FOX CANYON GROUNDWATER MANAGEMENT AGENCY

SUBJECT: Comments on Preliminary Draft Mound Basin Groundwater Sustainability Plan

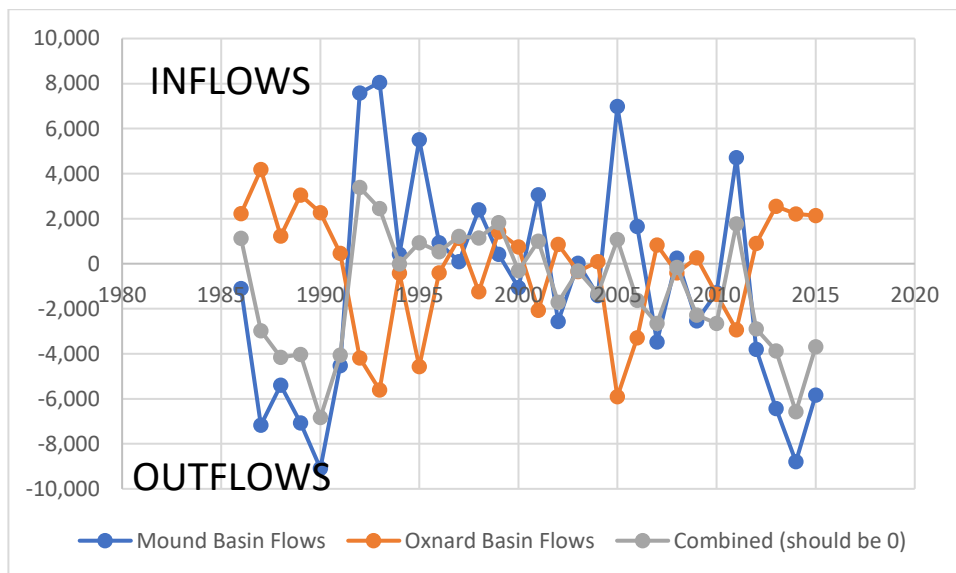
Table 3.3-03: Average flow between the Mound Basin and the Oxnard Subbasin in the Upper Aquifer System (UAS) matches reasonably well between the models used for each GSP. The Oxnard Subbasin GSP indicates average flow from 1986-2015 is 207 AFY from Oxnard to Mound. The Mound Basin GSP indicates average flow from 1986-2015 is 983 AFY from Mound to Oxnard. The two GSPs are off by about 1,200 AFY on average. The discrepancy appears to occur during drought years when the Mound Basin GSP shows higher outflows to the Oxnard Subbasin than the Oxnard GSP reports as inflows. Overall, the Mound Basin inflows / outflows are more varied in the Mound GSP than in the Oxnard GSP.
